February 16, 2023

RE: 22-125120-PLN
Reid Saunders Association
3985 Lindburg Road SE
Salem, OR 97302

We wish to express our appreciation for your timely review of the Construction Documents for Reid Saunders Association. Attached is your Plan Review Comments, and following are our proposed responses.

1 NORTH EXTERIOR ELEVATION
SCALE: 1/8" = 1'-0"

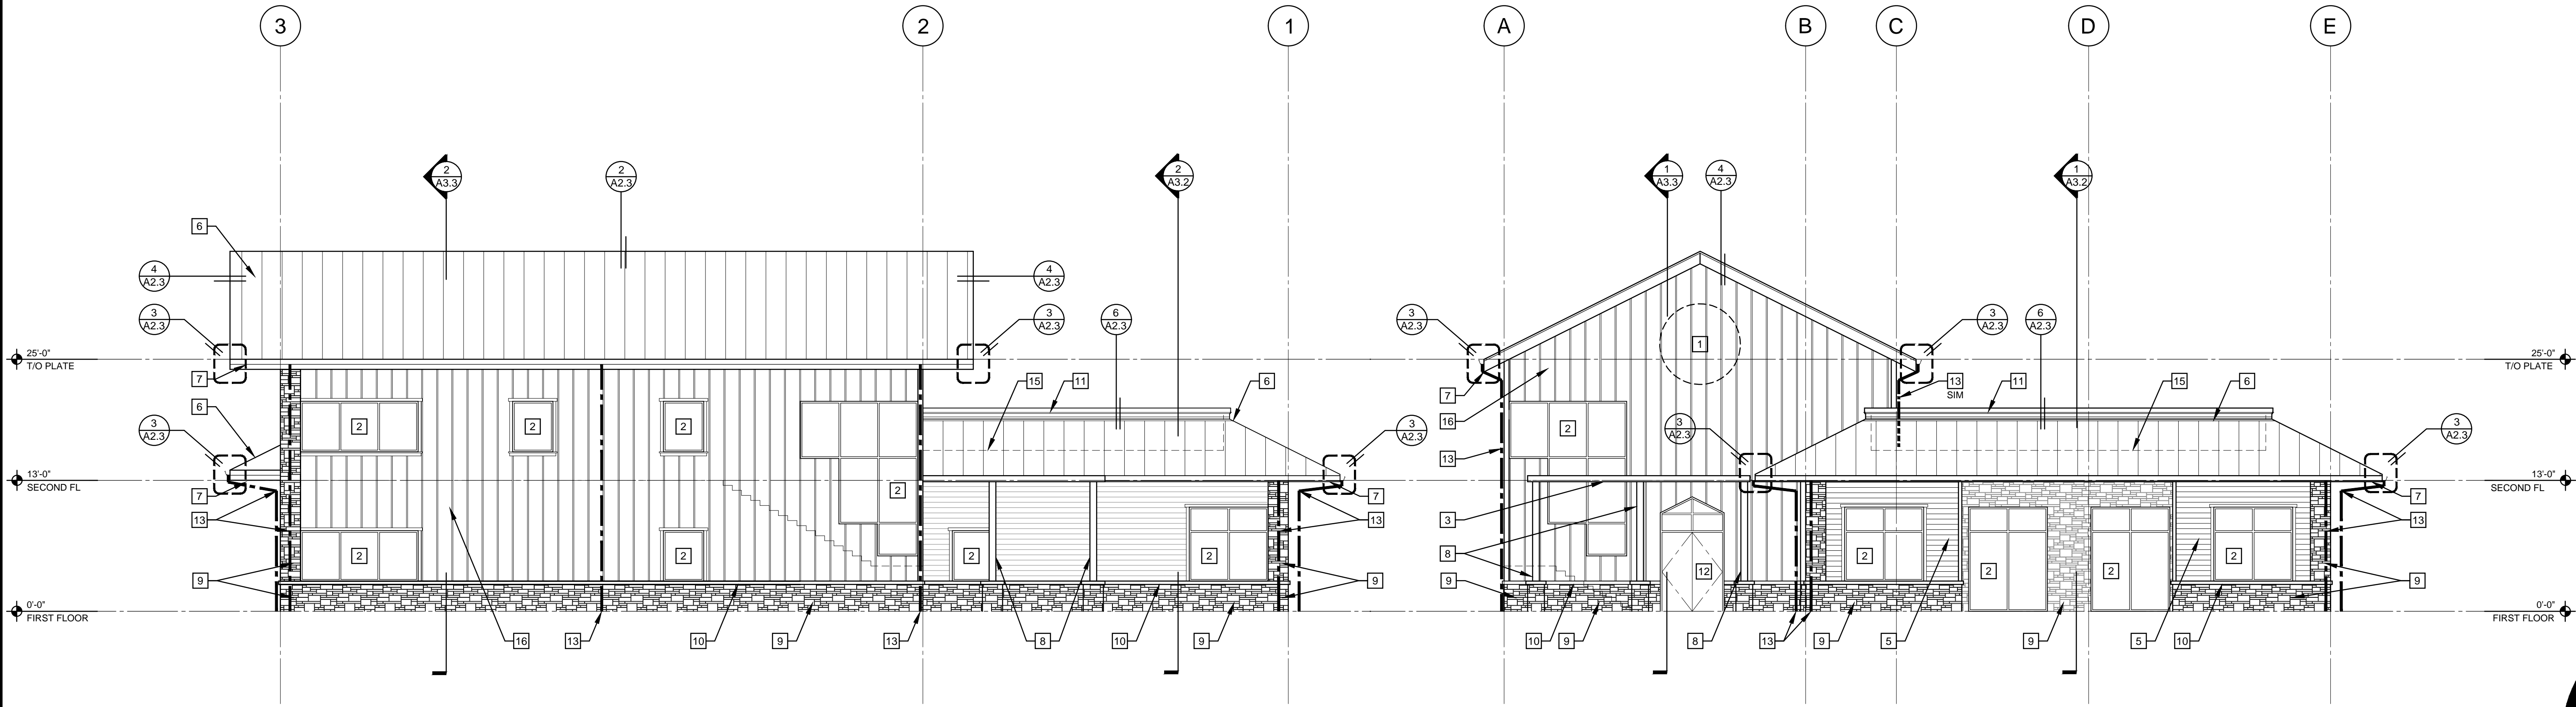
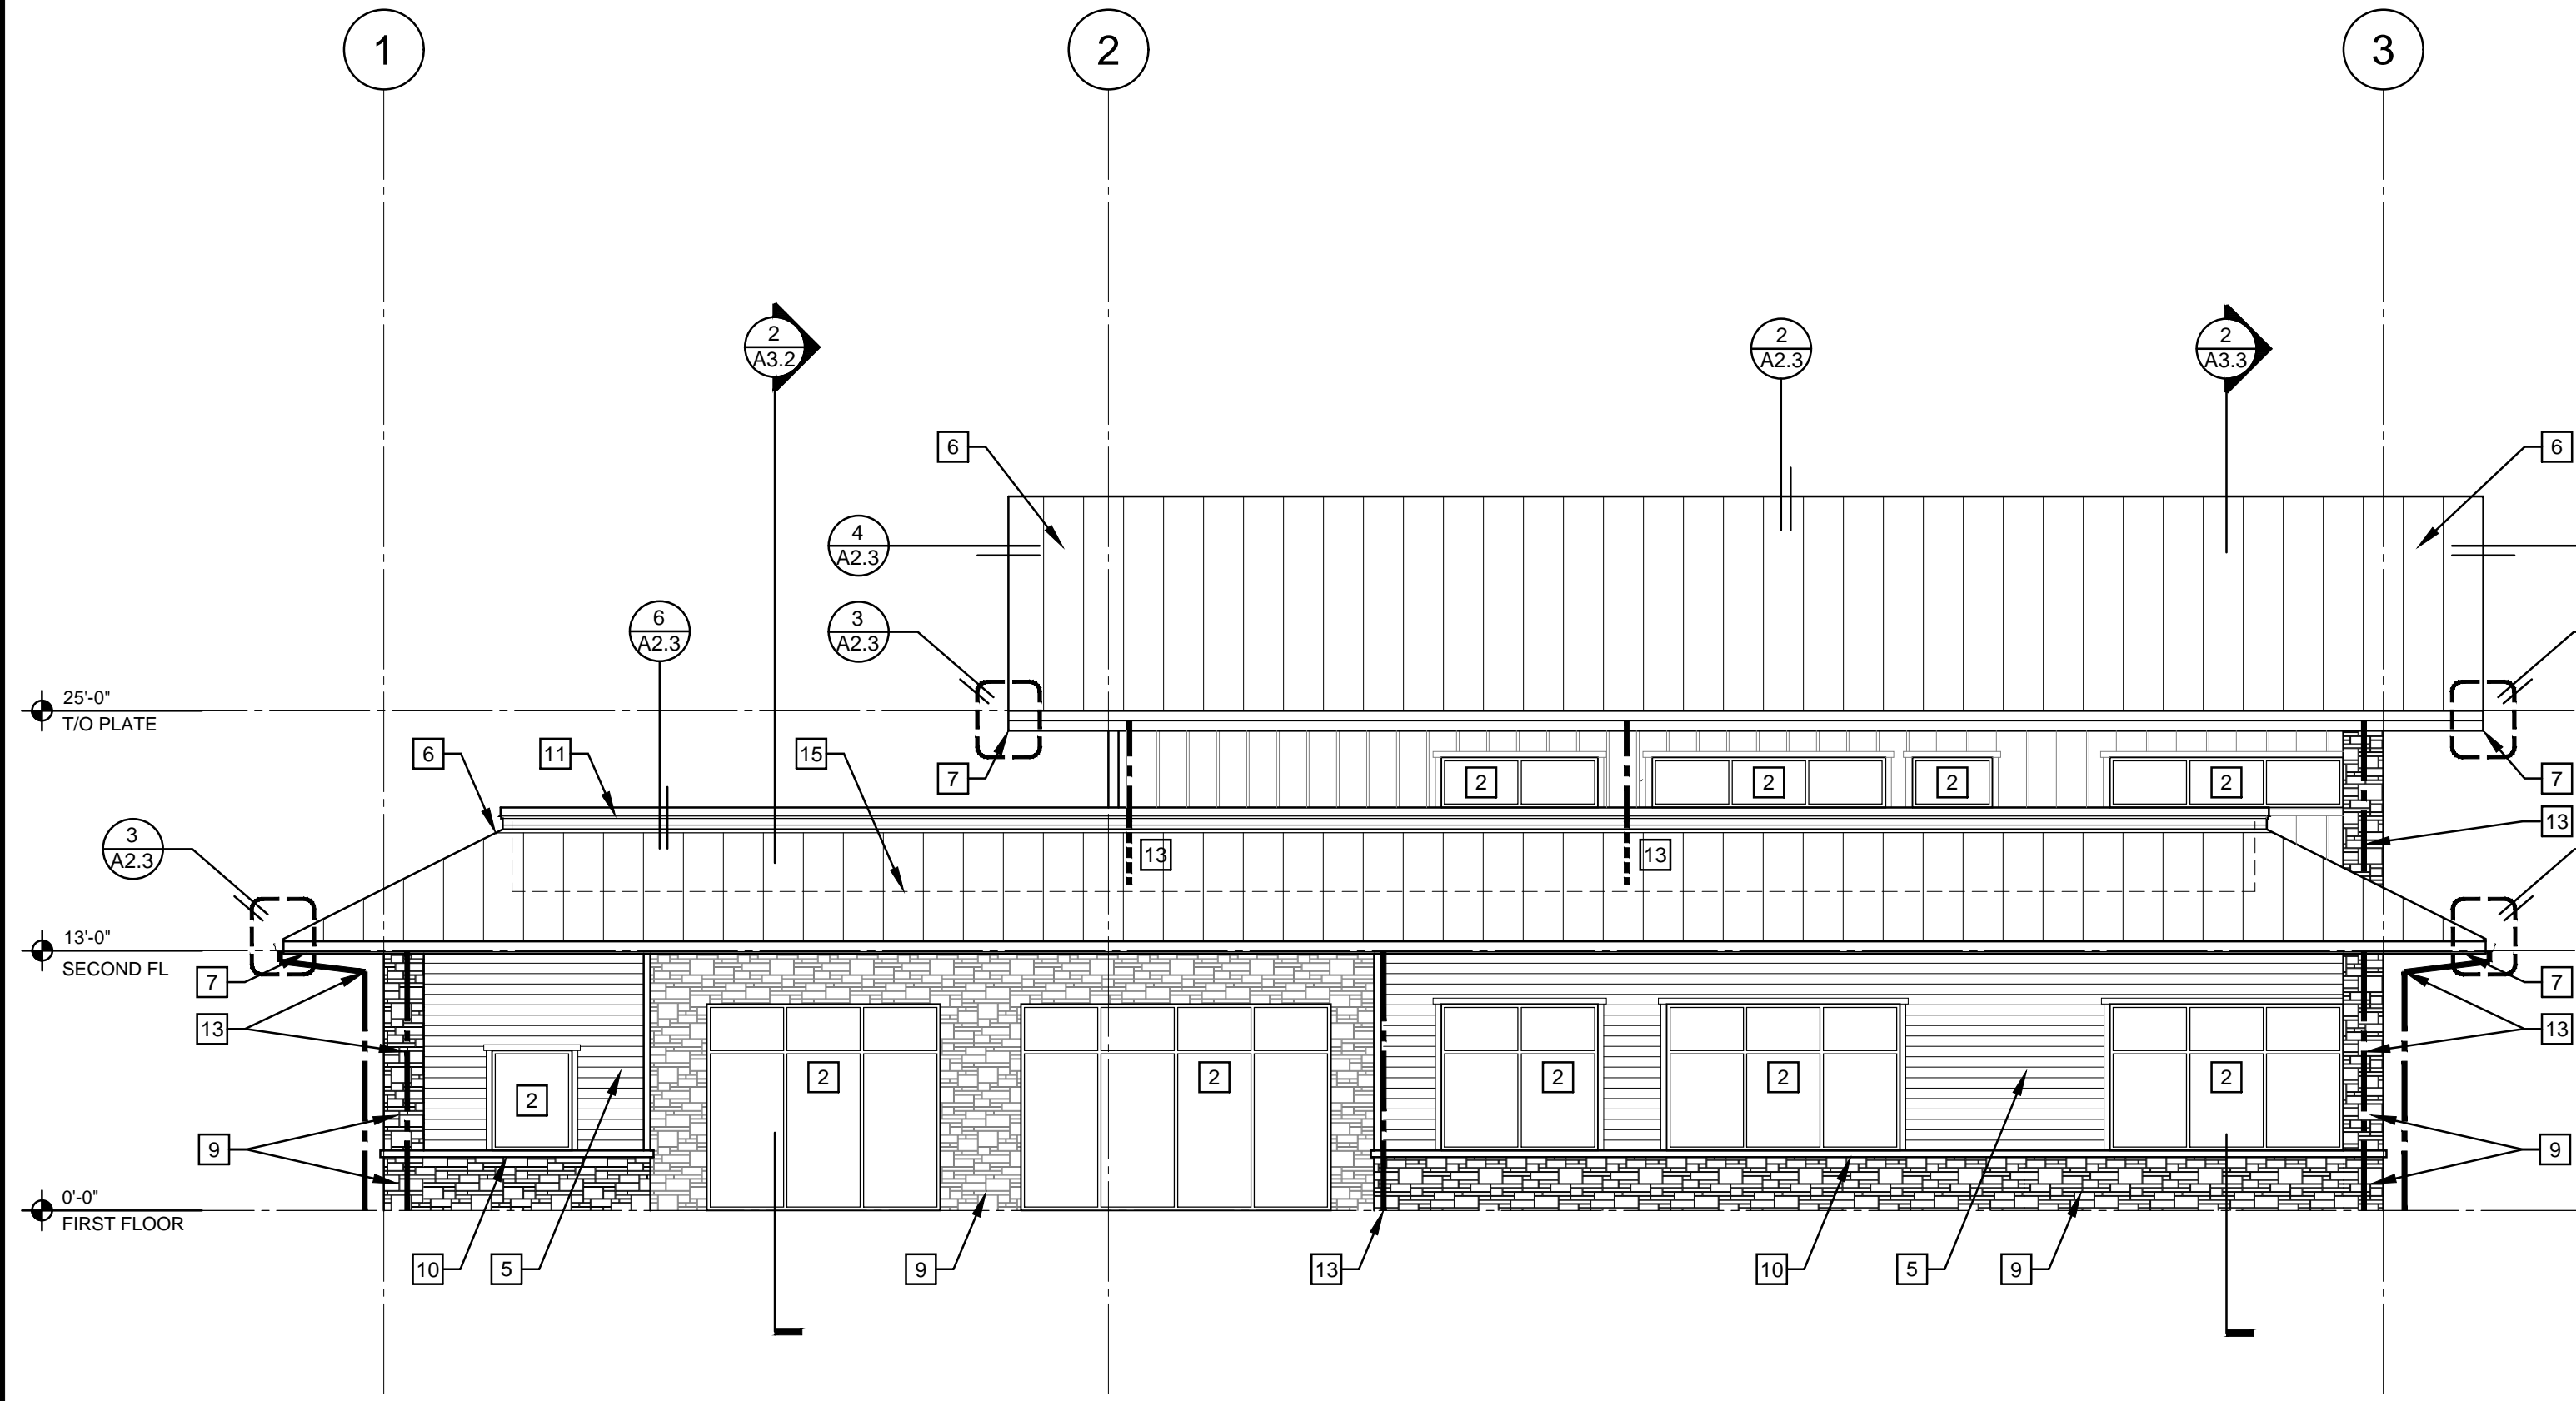
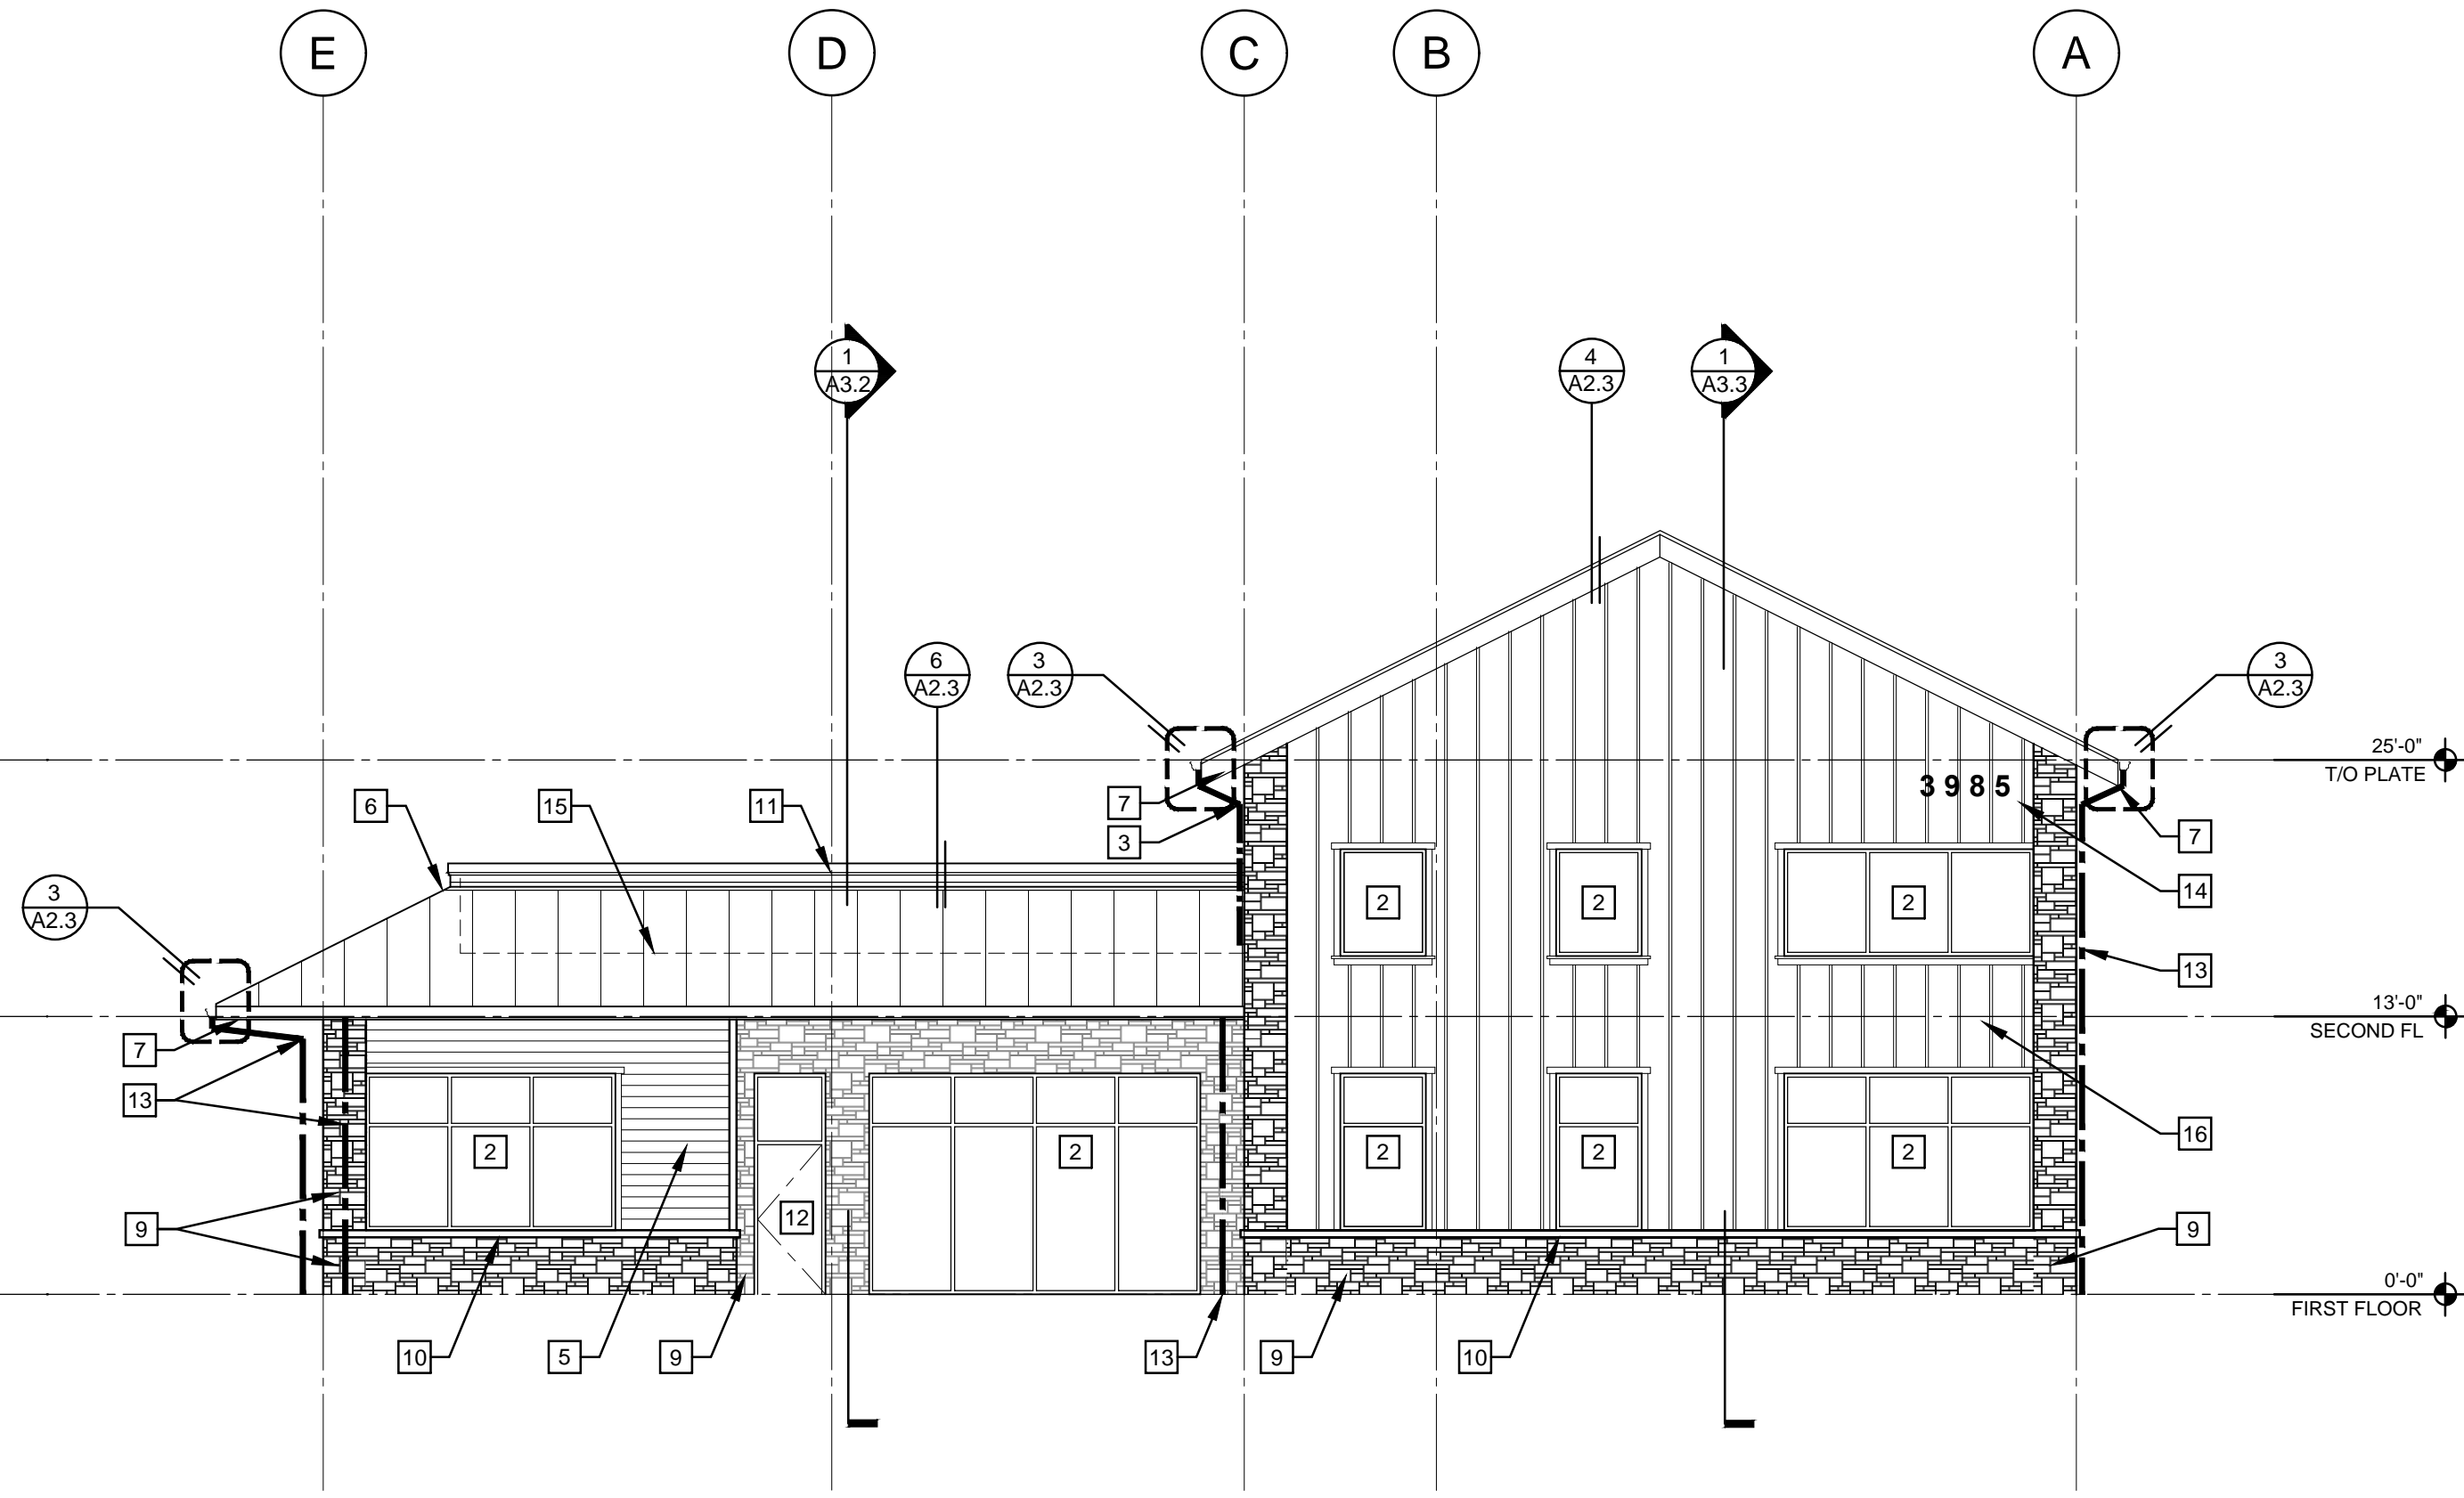
7. Elevations:
 - a. Building elevations are attached, refer to Sheet A3.1.
8. Transit Improvements:
 - a. Two Cherriots stops are now provided on the revised site plan. Refer to the attached Sheet A1.1.
